DEVELOPMENT DETERMINATION PANEL MEETING

WEDNESDAY 23 MARCH 2022

ITEM 3.1	DA2021/2278 - 36 RIVIERA AVENUE AVALON BEACH - ALTERATIONS AND ADDITIONS TO A DWELLING HOUSE INCLUDING A SWIMMING POOL
REPORTING MANAGER	Phil Lane
TRIM FILE REF	2022/157938
ATTACHMENTS	1 ↓ Assessment Report 2 ↓ Site Plan and Elevations 3 ↓ Clause 4.6

DEVELOPMENT APPLICATION ASSESSMENT REPORT

Figure 1: 3D representation of the proposed building form relative to the 8.5m building height with areas above 8.5m highlighted in red

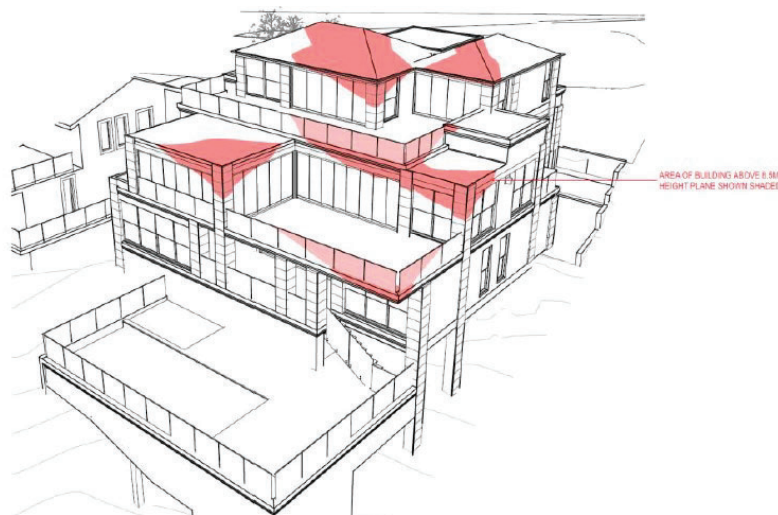
The variation to the 8.5m height limit is demonstrated in Figure 1 below. As shown, the extent of the variation is predominantly limited to the roof form and areas of open balustrading. The non-compliances generally occur as the land falls away steeply to the north and the west. The exceedances of the 8.5m is considered to be minor.

Figure 1: View angles over the subject site

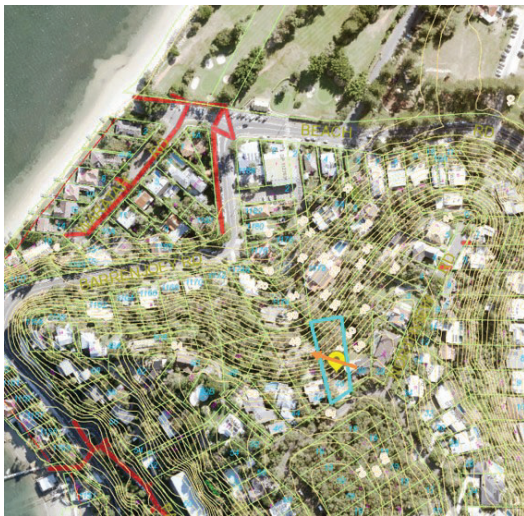
Figure 1 below shows the origin of the submissions relative to the subject site, and the view angles of the sites over the subject site (outlined in blue).

Figure 1: Envelope breach on the eastern elevation shown in green

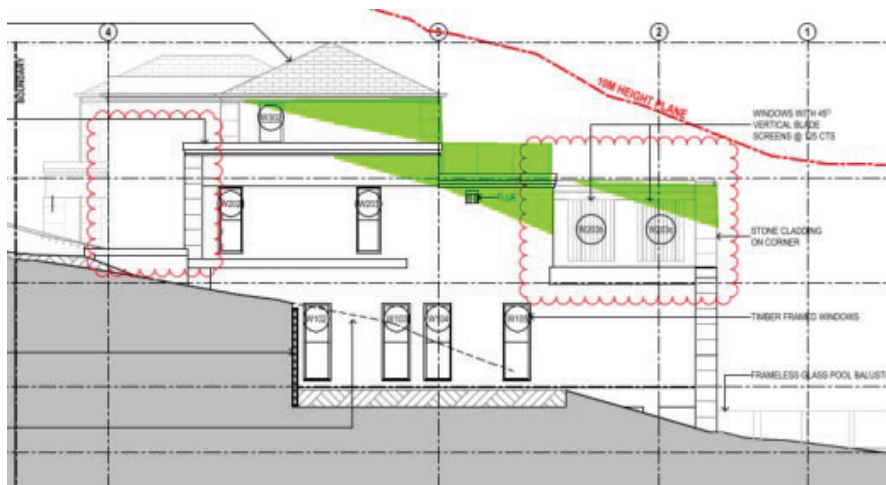
The proposed development encroaches into the prescribed building envelope along both the eastern elevation and western elevation. This variation is represented in figures 1 and 2 below.

This building envelope non-compliance is largely attributed to the slope of the site, which exceeds 30%. P21DCP allows for a variation to the prescribed building envelope for development on steep sites, subject to consistency with the outcomes of this Clause. Furthermore, amended plans were received during the assessment of this application which reduced the side boundary envelope non-compliance on both side elevations by reducing the overall height of the dwelling and increasing side setbacks.

Image 1: Height of building along the site from front (west) to rear (east).

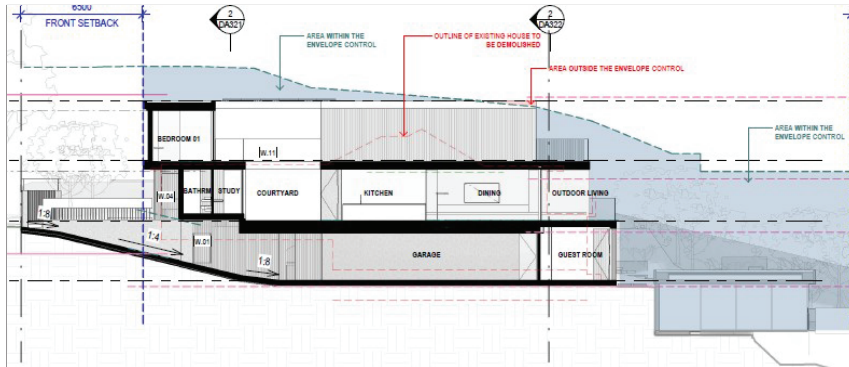
These levels give a minor non compliance of 120 millimetres (mm) at the eastern elevation roof parapet (See Drawing DA321 / B).

The building height is measured from an extrapolated existing ground line across the central building footprint which is consistent with the practical method adopted by the NSW Land and Environment Court in *Bettar v Council of the City of Sydney* [2014] NSWLEC 1070. In this, the court regarded that it was unhelpful when measuring height to follow excavation lines below ground level that "*results in an absurd height plane with a large and distinct full storey dip in it as it moves across the site*". Therefore, across the majority of the building the roof area the dwelling is under 8.5m height as indicated in the section diagram below.

Image: Height plane overlay and image of surrounding development.

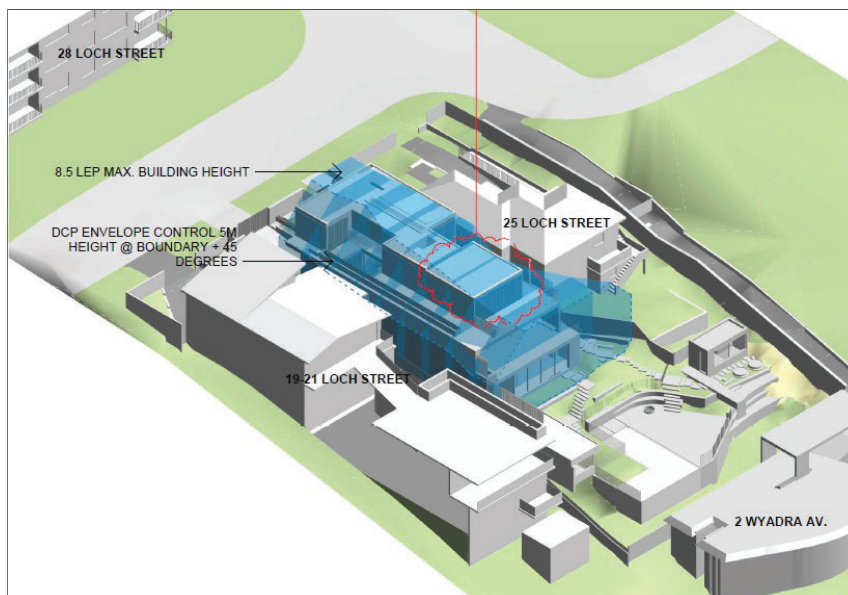
- The proposed development will not adversely impact on views of the adjoining dwellings to the north and south, due primarily to the fact that the proposed dwelling has a proposed rear setback significantly greater than the Rear Boundary Setback control.

- The breaching portions of the proposed Dwelling are setback a greater than required distance from the side and rear boundaries of the subject site, incorporating significant articulation.

Image: Side elevation of dwelling showing building height, wall height and southern wall plane elements. Note privacy screen at lower ground level.

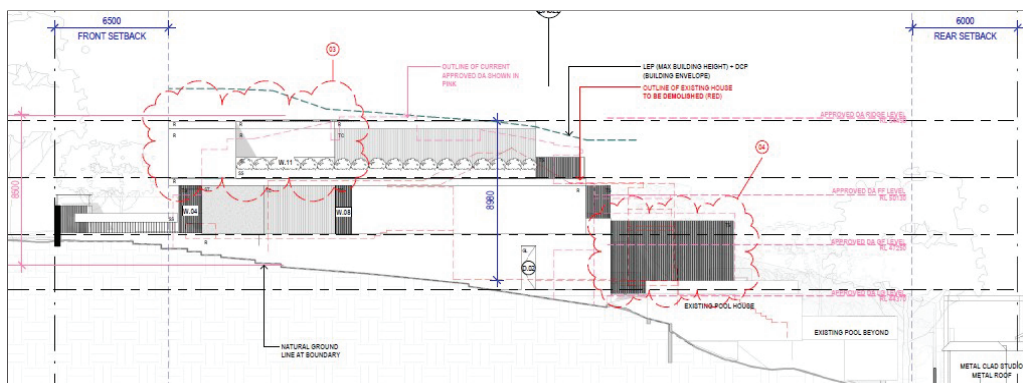
The non-complying sections of wall are limited to the corner of the side walls and across southern (front) elevation of the building which is influenced by the natural slope of the land and gradients required for the garage level below. Impacts on views from public domain are not unreasonable in the context of the pattern of development and broad views available. The balcony blade walls and screens assist to maintain reasonable amenity impacts with respect to privacy for adjacent land. No unreasonable amenity impacts of overshadowing, privacy, or spatial separation impacts will result from the wall non-compliant wall height with regard to adjoining private properties.

Figure 4: Side section showing non-compliance with 8.5m height plane and side boundary envelope.

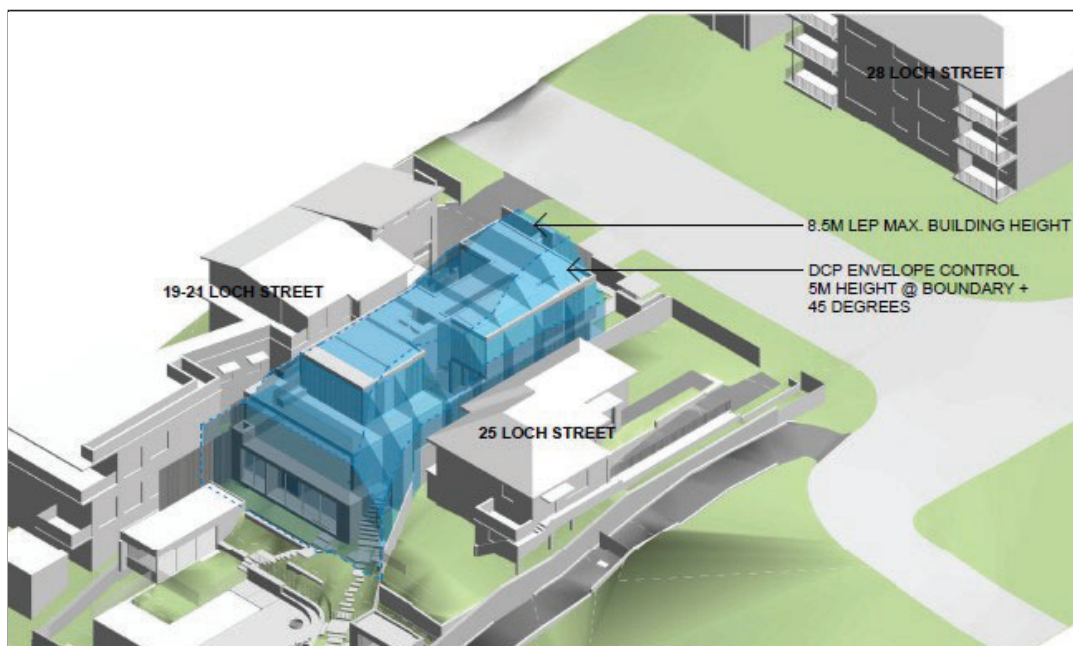
section of the building around bedroom 1 blocks the appearance of the rear (non-complying elements) from being readily visible. The use of a flat roof form allows a lower building profile closer to the street. However, at the rear of the proposed dwelling where the land falls away the elongated floor span has influenced the non-compliance with the side boundary envelope, wall height and maximum building height.

Overall it is considered that a fully compliant 2 storey dwelling design would not materially improve view sharing for either No.26 or No.28 Loch Street, given the site potential for a higher front section of the building.

Image: Proposed fence and portico entry. (Existing fence steps down from left side to right side)

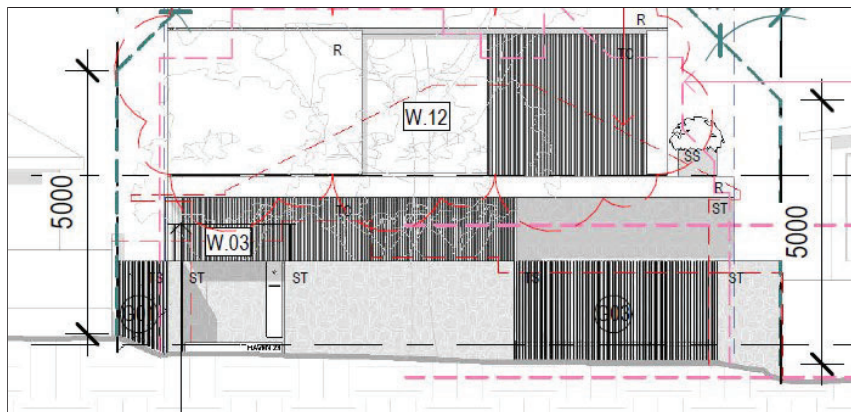
The proposal does not demonstrate an 'innovative design' to improved the urban environment of the streetscape given this part of the DCP seeks requirements of low fencing to encourage passive surveillance, fencing with articulation and landscaping elements to soften the streetscape. Solid wall fences are generally limited to high traffic vehicle zones (main roads) which Loch Street is not.
